**TOWN OF NEWBURGH
PLANNING BOARD
TECHNICAL REVIEW COMMENTS**

PROJECT: CORTLAND COMMONS
PROJECT NO.: 2017-11
PROJECT LOCATION: SECTION 9, BLOCK 1, LOT 60
REVIEW DATE: 28 JULY 2017
MEETING DATE: 3 AUGUST 2017
PROJECT REPRESENTATIVE: JMC PLANNING & ENGINEERING

Response to MH & E "Town of Newburgh Planning Board Technical Review Comments", dated 03/16/2017

22

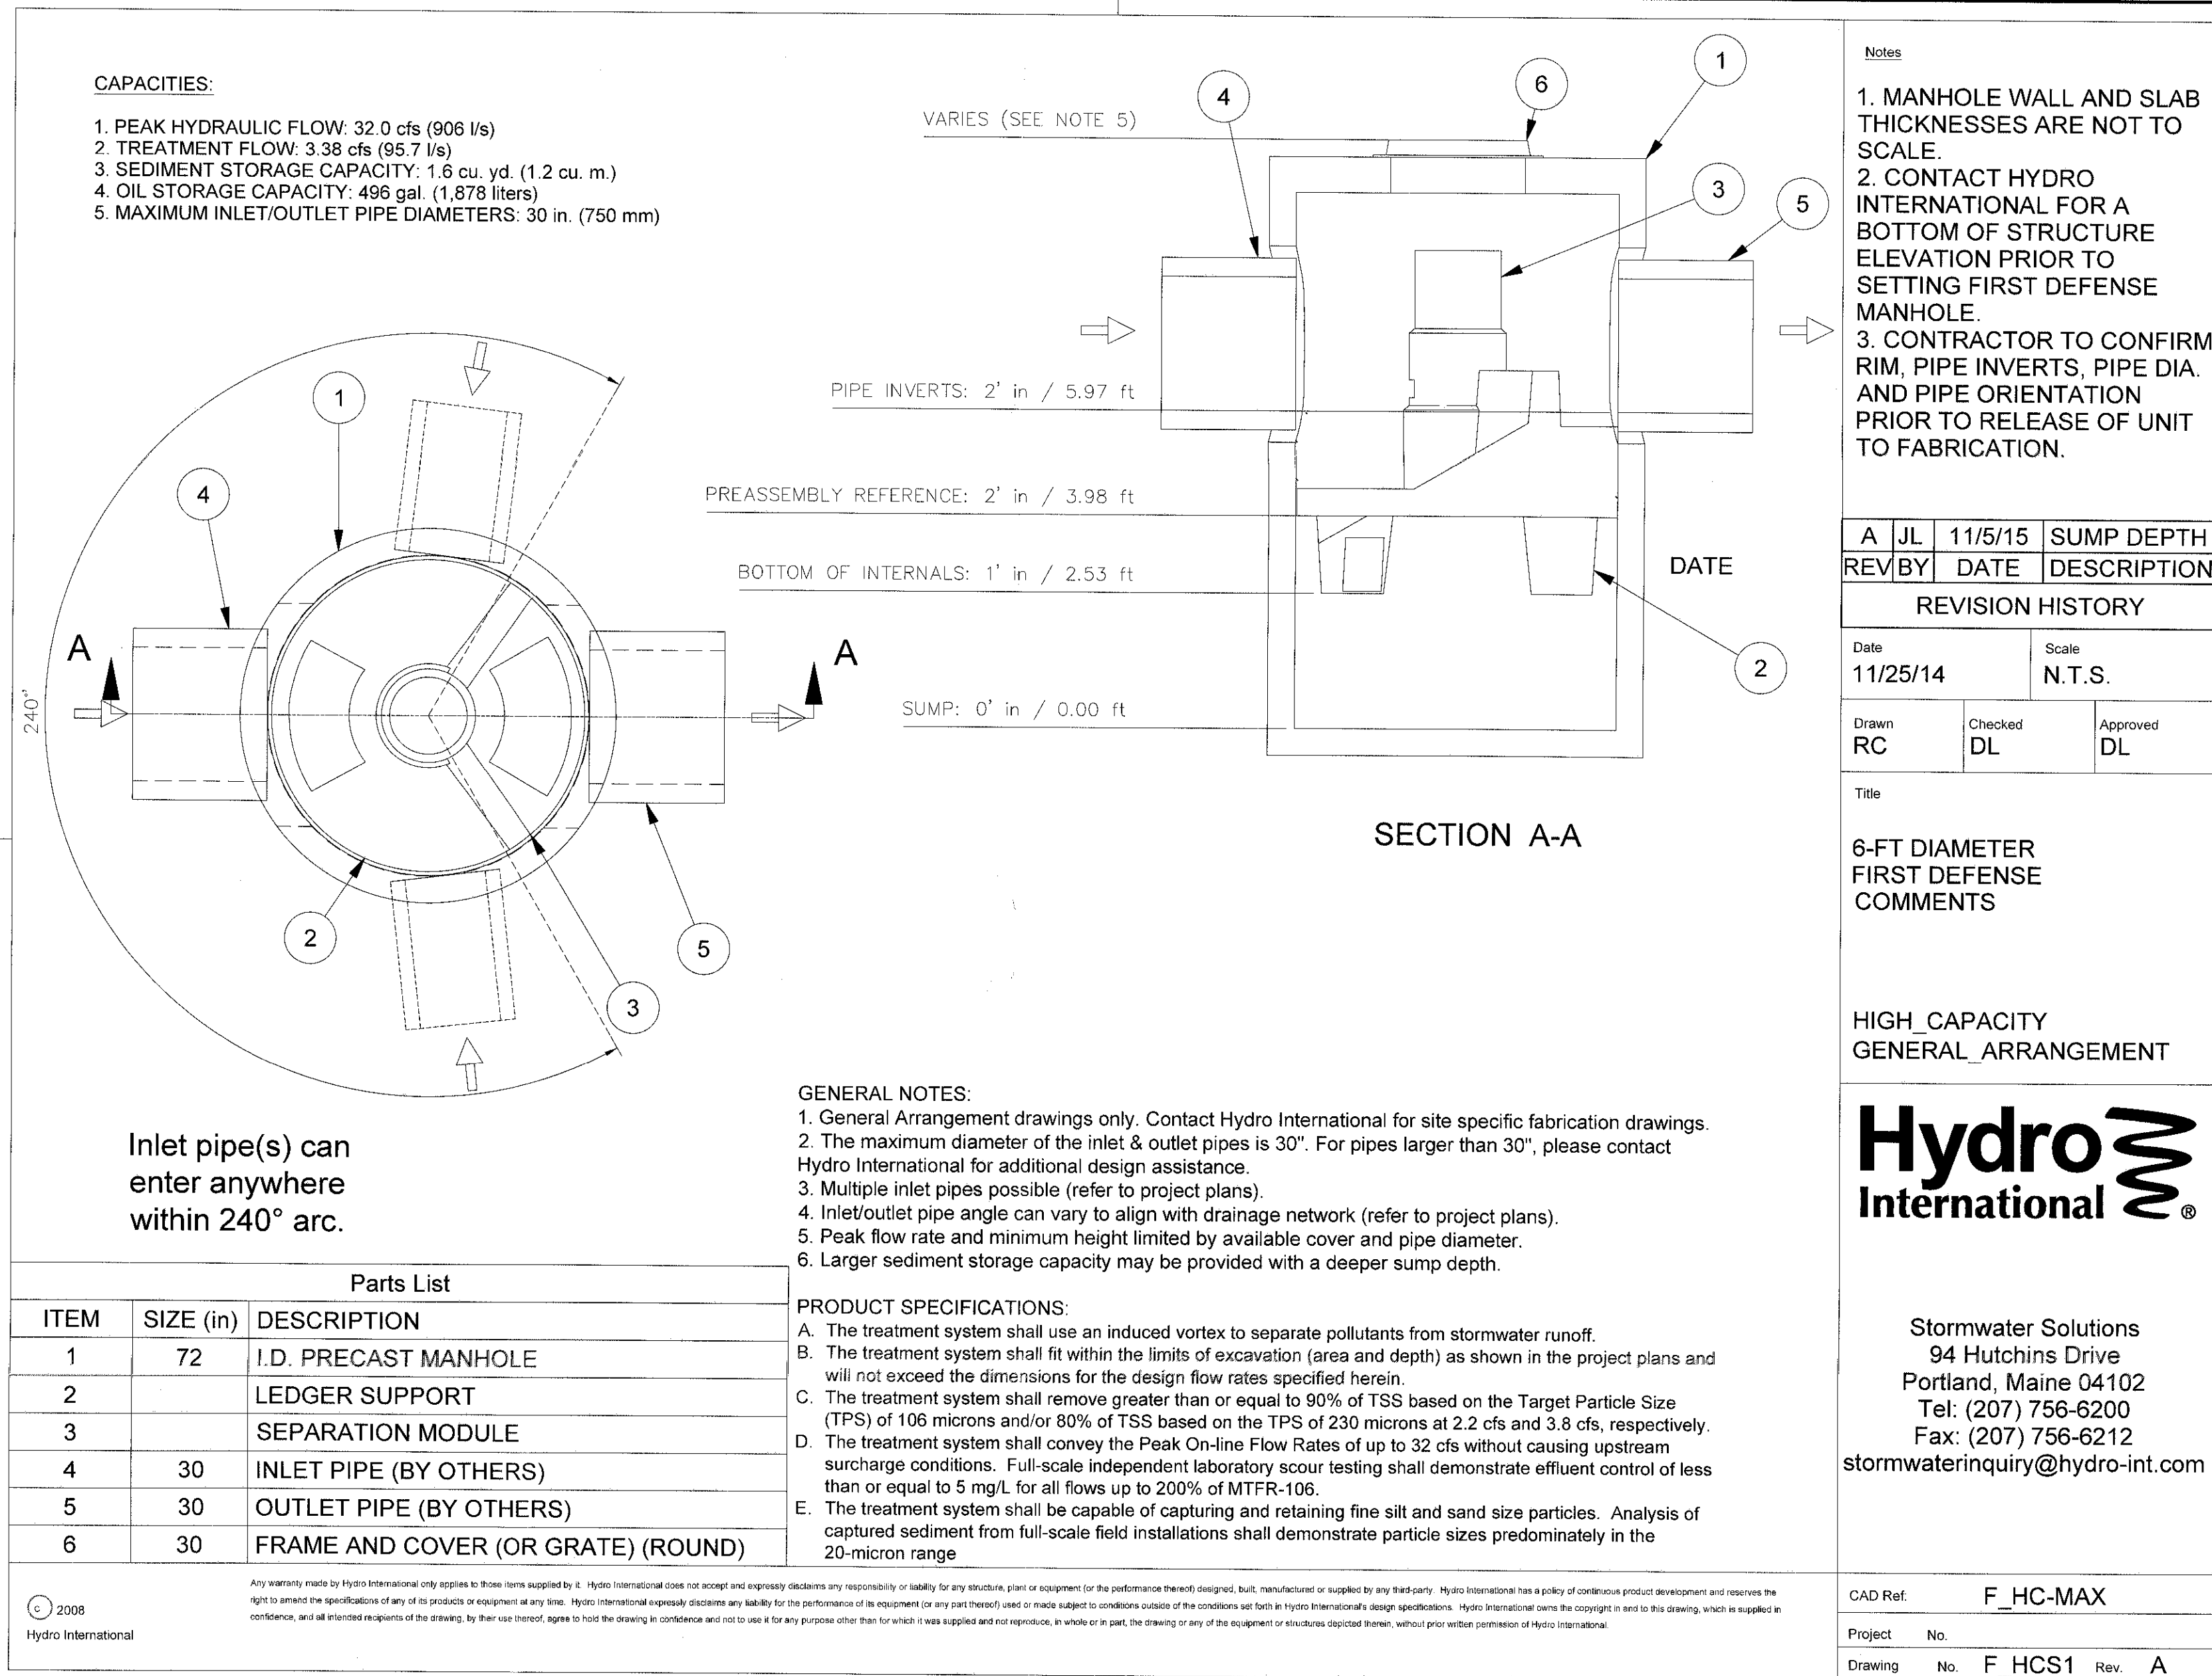
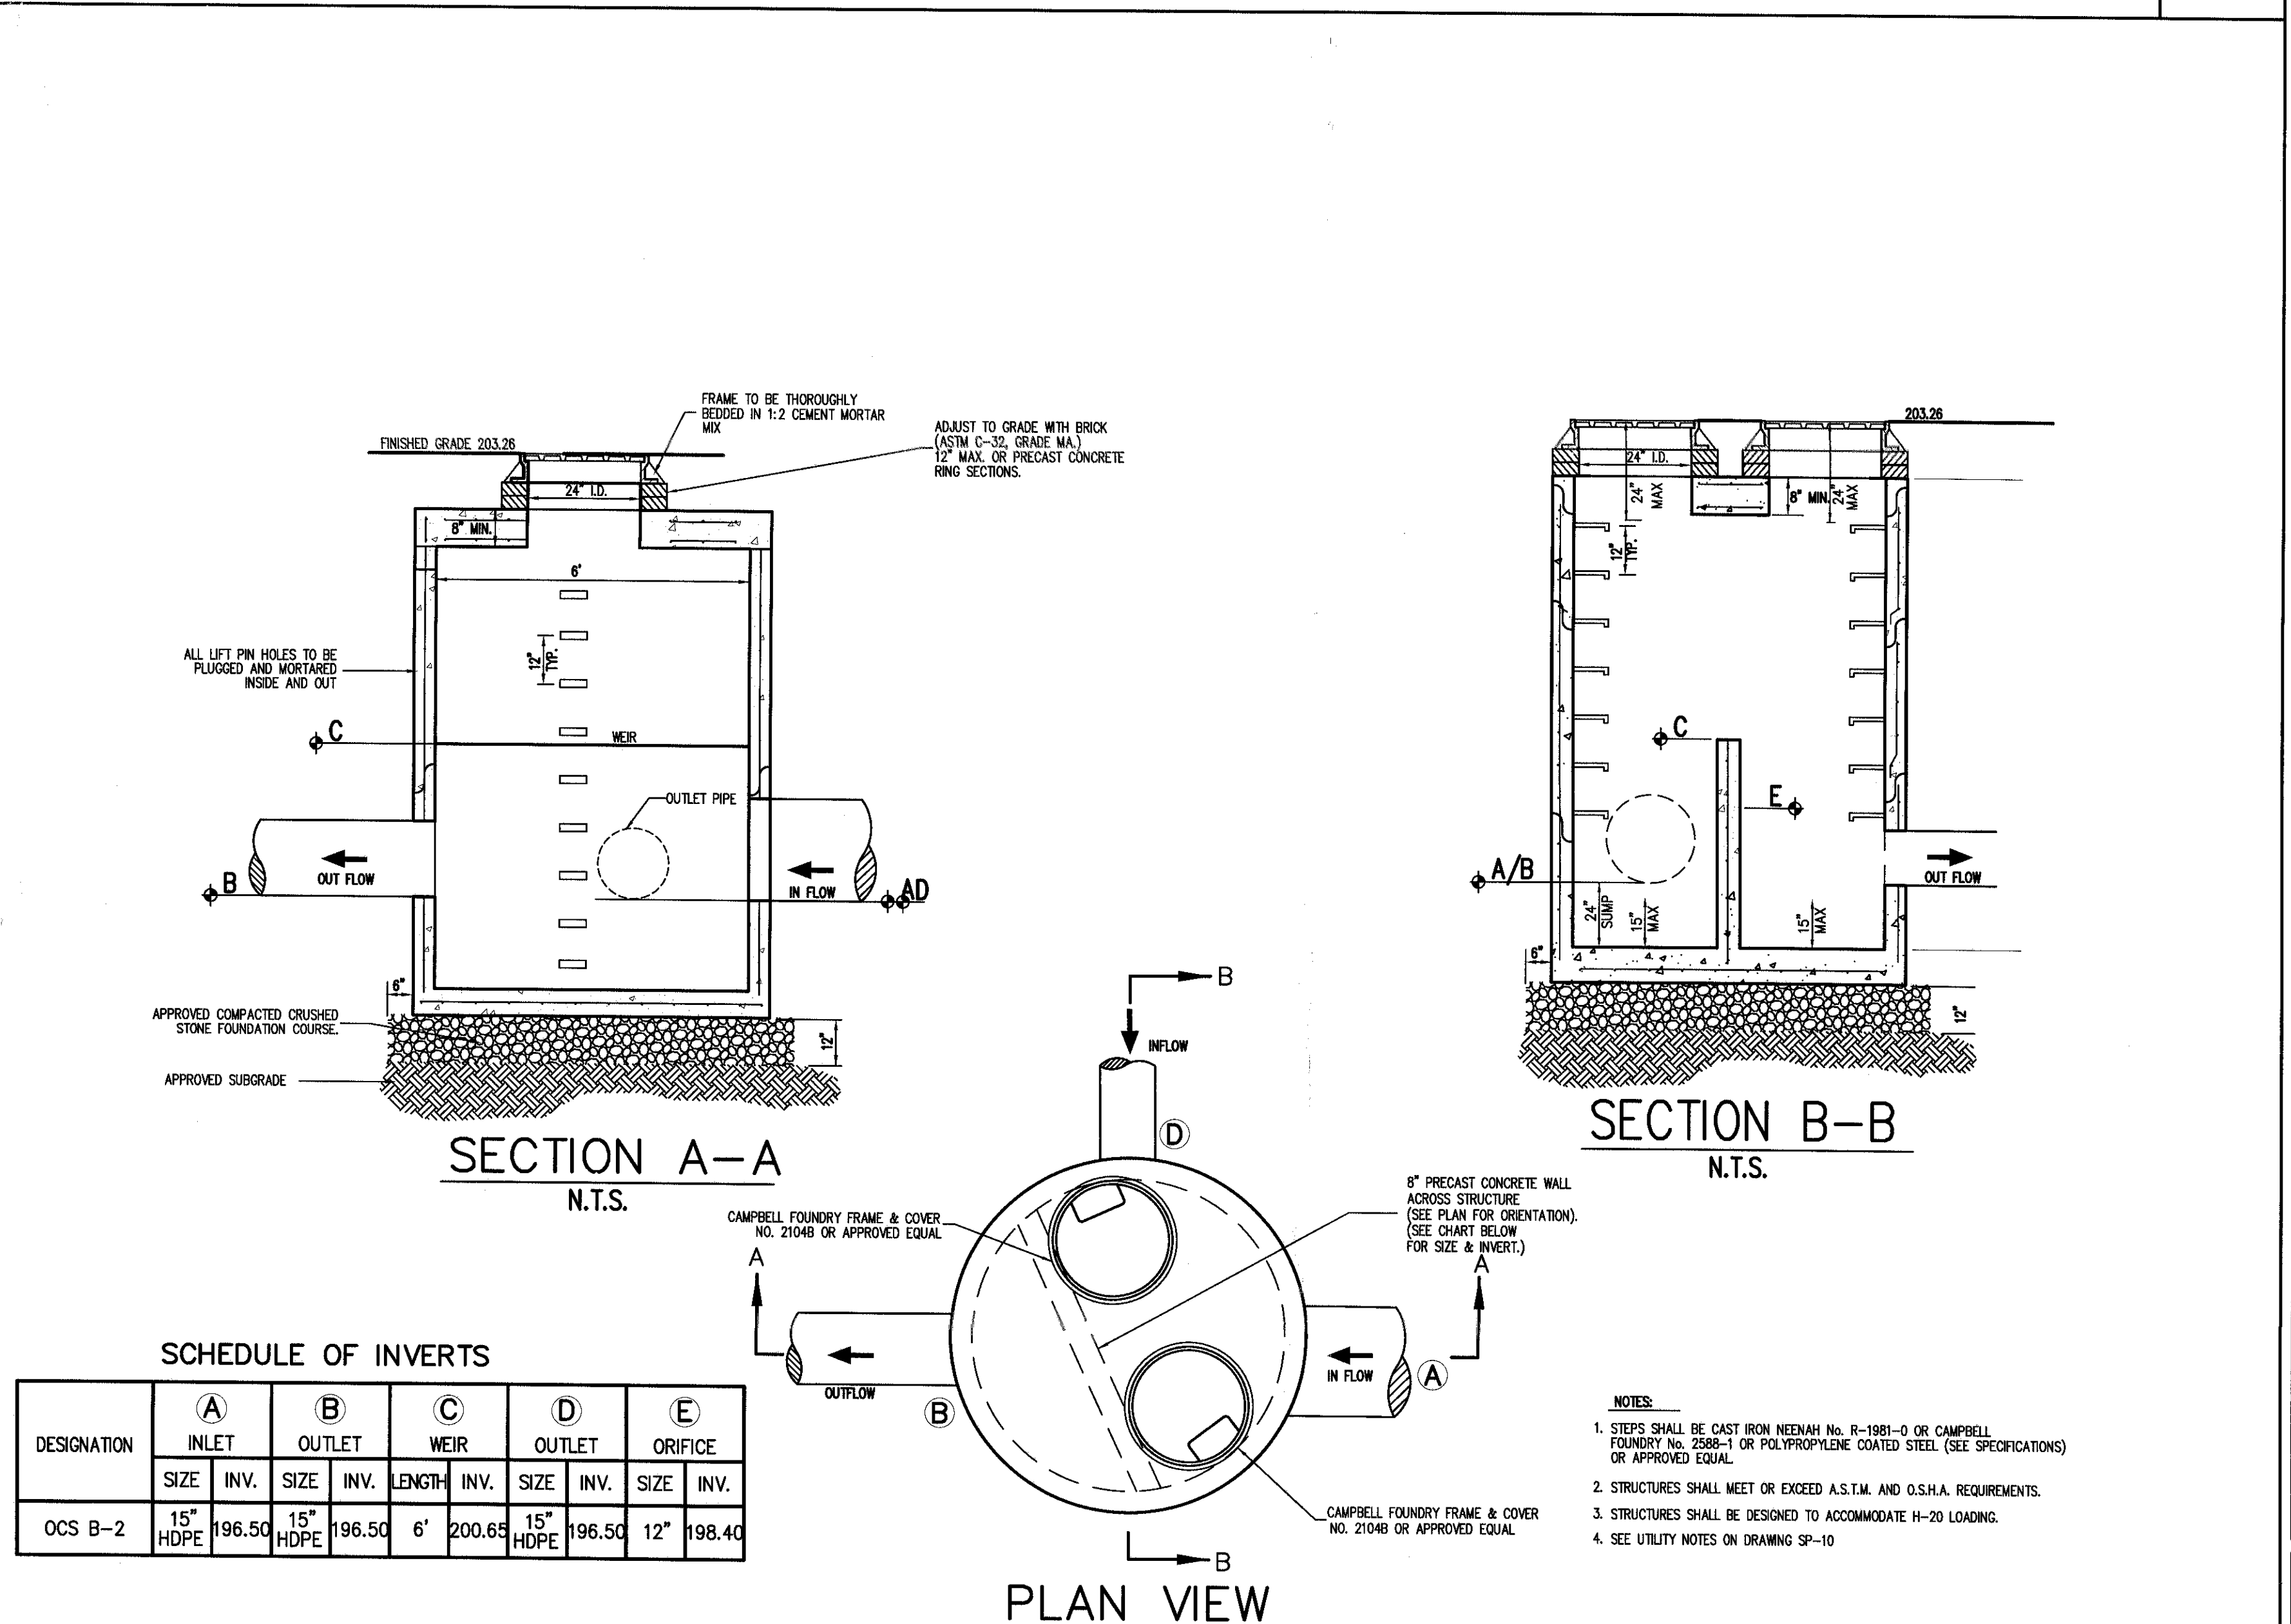
7. Two details of the bypass manhole up gradient of the infiltration structure are included in Detail #13 & 24. These should be labeled for clarity.
8. The Applicant's representative is requested to detail the connection to the NYSDOT 24 inch RCP.
